Technical Service Bulletin (TSB)

Fuel Tank Protection Covers Missing

REFERENCE:	TSB: 14-006-25 GROUP: 14 - Fuel	Date:	February 21, 2025	REVISION:	-
VEHICLES AFFECTED:	2025 (B1) Jeep Renegade This bulletin applies to the vehicle built on or after July 09, 2024 (MDH 0709XX) and on or before January 25, 2025 (MDH 0125XX) equipped with 1.3L I4 Turbo Mair DI Eng w/ESS E100 (Sales Code EYJ).			MARKET APPLICABILITY: ☐ NA☐ MEA ☒ SA☐ IAP ☐ EE☐ CH	
CUSTOMER SYMPTOM:	Customers may comment on the following: Fuel tank protection covers are missing.				
CAUSE:	Manufacturing issue

Fig. 2
Support Bracket

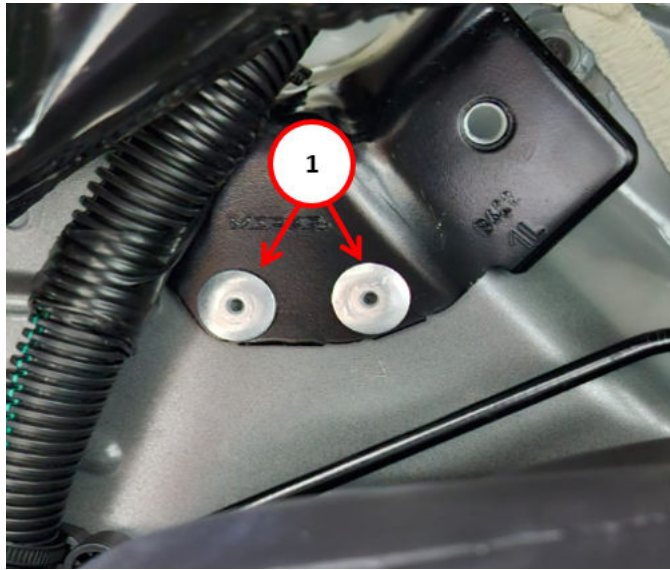
3. Position support bracket on the left-hand floor and secure using two rivets with a manual riveter [Fig. 2](#).

Fig. 3
Support Bracket Rivet

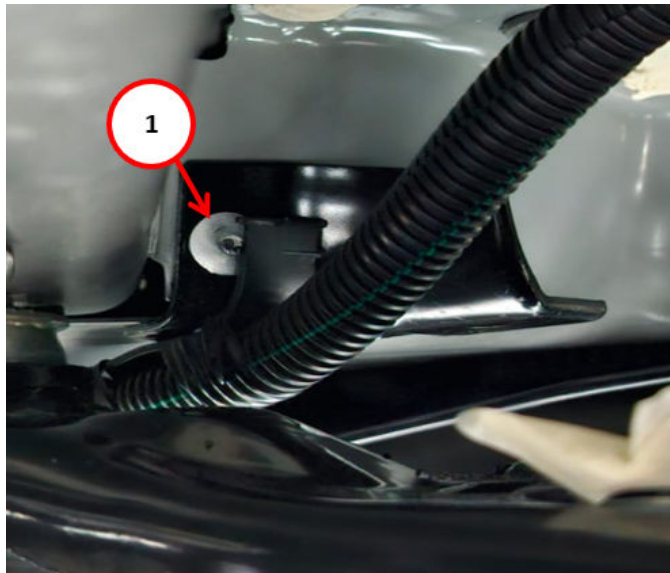
4. Apply the third fixing rivet to the support bracket and then insert the harness clip into the previously fixed bracket [Fig. 3](#).

Fig. 4
Fixing Plug Locations

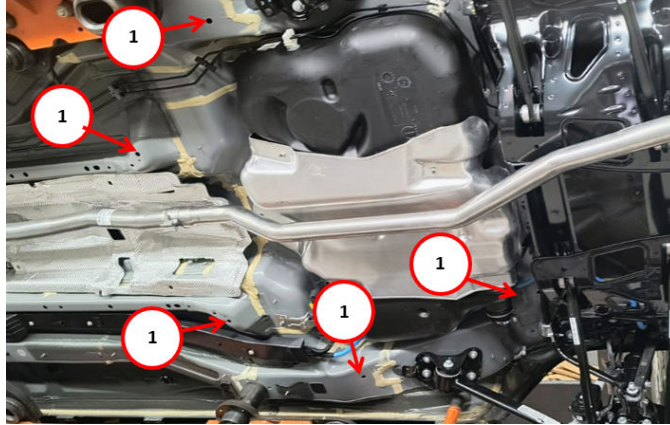
5. Insert five fixing plugs (three on the right side and two on the left side of the floor) using a manual riveter with an M8 threaded tip [Fig. 4](#).

Fig. 5
Fuel Tank Protection Covers

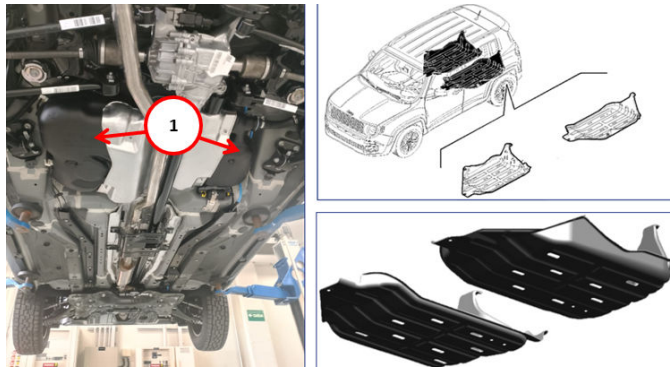
6. Position the fuel tank protection cover on the left side and hand tighten the three screws (two on the floor and one on the support bracket) [Fig. 5](#).

7. Position the fuel tank protection cover on the left side and hand tighten the three screws on the floor [Fig. 5](#).
8. Tighten all six fuel tank protection cover screws to 24 N·m (18 ft. lbs.).
